**TOWN OF HORIZON CITY
Planning and Zoning Commission Staff Report**

Case No.: **SDP24-0002**
Verdancia Unit 1

Application Type: **Preliminary Plat**

P&Z Hearing Date: September 16, 2024

Attachment 4: Preliminary Plat North

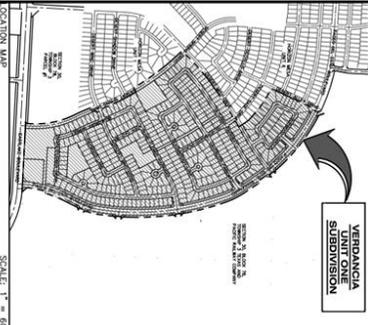
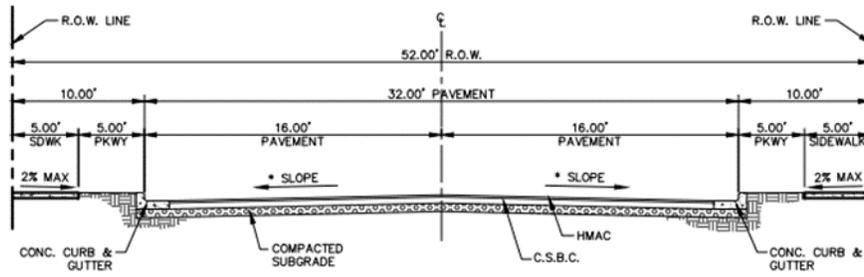
1. Correct note #9 to Town of Horizon City.
2. Verify notes 24,25,26 with Planning Department.
3. Add a note stating sidewalk to be constructed by developer in areas abutting pond, park and drainage easements.
4. Proposed street cross sections, pending legal department approval.
5. East and west side address numbers shall be 3 DIGITS (see section 107.090 ORDINANCE 00107).
6. Provide Drainage calculations. (See ordinance 4.2.2.6 section d Developed storm water shall be addressed in the drainage study).

- ~~1. Address all corrections and/or redlines on all sheets.~~
- ~~2. Provide metes and bounds for platted area. Make sure that the bearings in the curve tables and metes/bounds match.~~

- ~~3. Use a darker line type for subdivision boundary.~~
- ~~4. Provide a closure report for the subdivision and individual lots to ensure closure.~~
- ~~5. Provide a proposed location of the U.S. Postal Service Delivery Collection Box Units. Include in the legend a symbol and description of the collection box units.~~

- ~~8. Provide an AutoTURN analysis for a fire truck with the longest wheel base and length of truck based at the Horizon Fire Department, ESD No.1. Analyze the turning movements at all cul-de-sacs with landscape areas and at intersections where street provide raised medians.~~

- ~~9. Coordinate with the Town of Horizon City with regard to any additional comments they may have.~~
- ~~10. Verify area in the legal description.~~
- ~~11. Verify roadway names are consistent on the plat in all locations.~~

- ~~12. Show size and location of existing utilities tying into the new subdivision~~

~~Please add a 12' wide easement along Eastlake Blvd and Paseo Del Est Blvd for potential future installation of electrical lines.~~

~~On Block 1, I don't see lot 12, it jumps from 11 to 13, can you please double check lot me know if there is an error.~~

Attachment 7: Proposed Right-of-Way Cross Sections & Cul-De-Sac Design

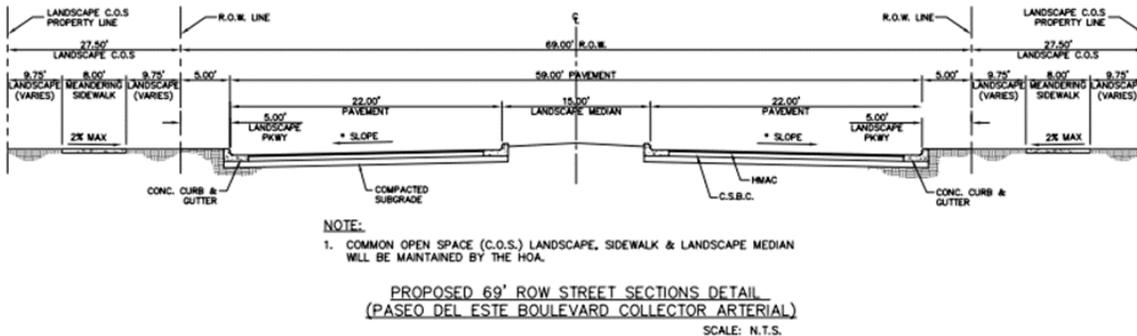
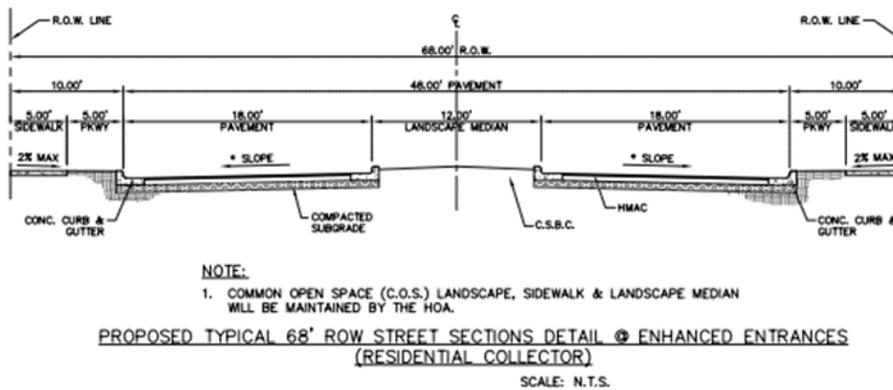
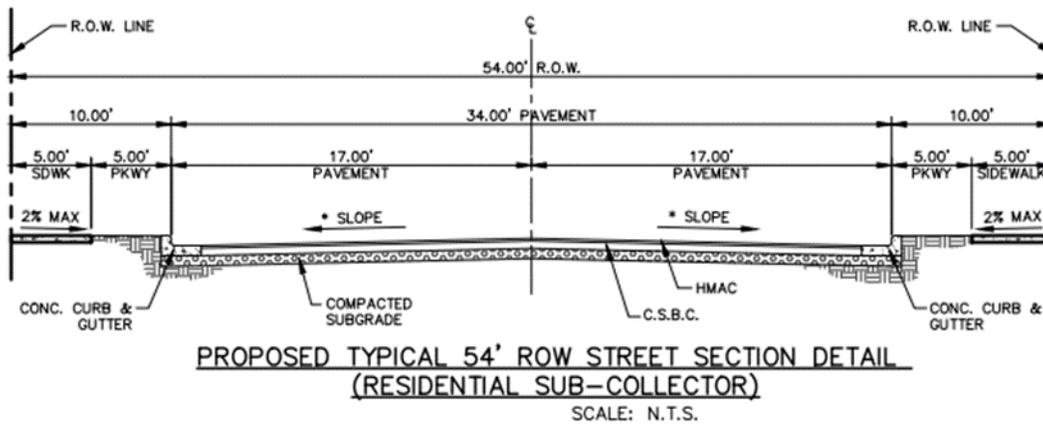
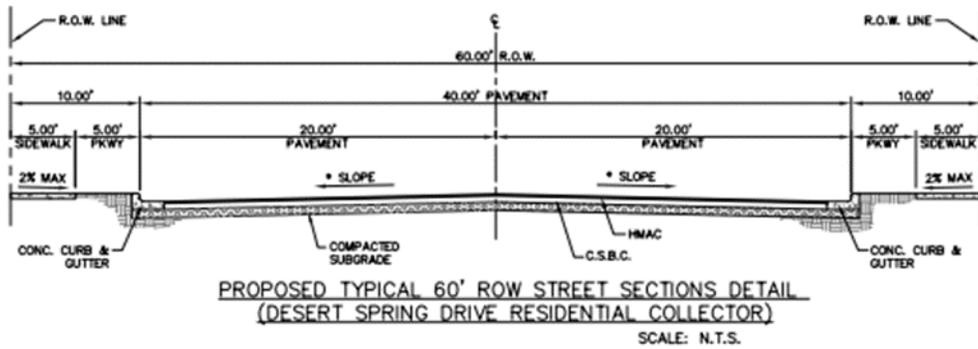
1. Modification from a 52-ft wide residential sub-collector street right-of-way to a 54-ft wide street right-of-way at all local residential sub-collector streets. The 54-ft street will consist of two 5-ft parkways, two 5-ft wide concrete sidewalks and a 34-ft wide pavement structure with curb & gutter. This right-of-way will coincide

2. Modification to use a 60-ft wide street right-of-way residential collector, which consist of two 5-ft parkways, two 5-ft wide concrete sidewalks, two 40-ft wide pavement structures with curb & gutter. This right-of-way will be consistent with the adjacent existing residential collector street of Desert Springs Dr. to the west.

3. Modification to use a 68-ft wide residential collector at enhanced neighborhood entrances. The 68-foot street will consist of two 5-ft parkways, two 5-ft wide concrete sidewalks, two 18-ft wide pavement structures and a 12-ft raised landscape median with curbs & gutter. Landscaped areas will be maintained by the HOA.

4. Modification from an existing 74-ft wide collector arterial street right-of-way to a 69-ft wide collector arterial street right-of-way, along Paseo Del Este Blvd. The proposed 69-ft collector arterial street will consist of two 5-ft landscape parkways, two 22-ft wide pavement structures and a 15-ft raised landscape median, with curbs & gutter. The sidewalk will consist of an 8-ft wide concrete structure and will be located adjacent to this right-of-way, and meandering within the abutting Common Open Space 27.5-ft wide landscaped buffer. This will provide a visually appealing and safe walking trail along this corridor. Landscaped areas will be maintained by the HOA.

Staff recommends approval of Verdancia Unit 1 Preliminary Subdivision Plat on a Preliminary basis and approval of the requested ROW street modifications and ROW stub out vacation.

CUL-DE-SAC WITH LANDSCAPE ISLAND

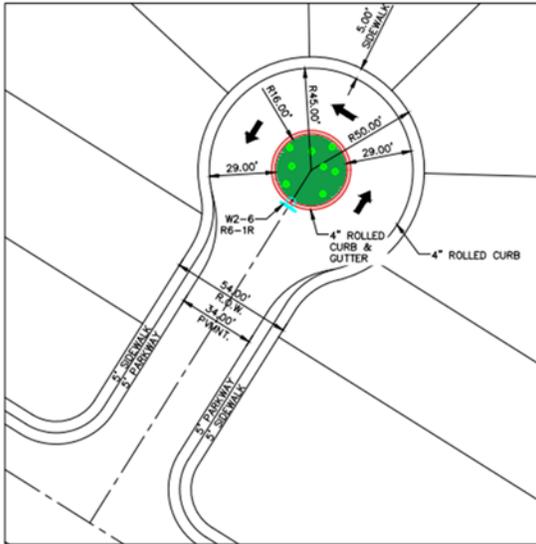
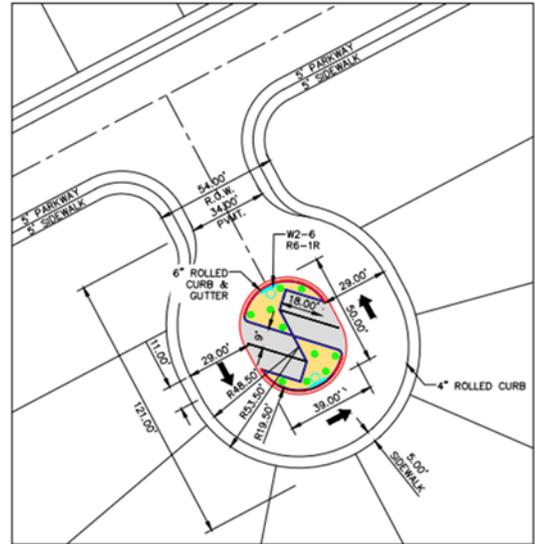
5. Modification from a 50-foot radius cul-de-sac street to a 50-ft and a 53 % -foot radius cul-de-sac with interior parking/landscape islands. The proposed cul-de-sac and parking/landscape islands will enhance the neighborhood character, reduce the impervious surface, and aid to eliminate typical cul-de-sac "stack" parking, while maintaining adequate room for emergency vehicle turning movement. Landscape areas will be maintained by the HOA.
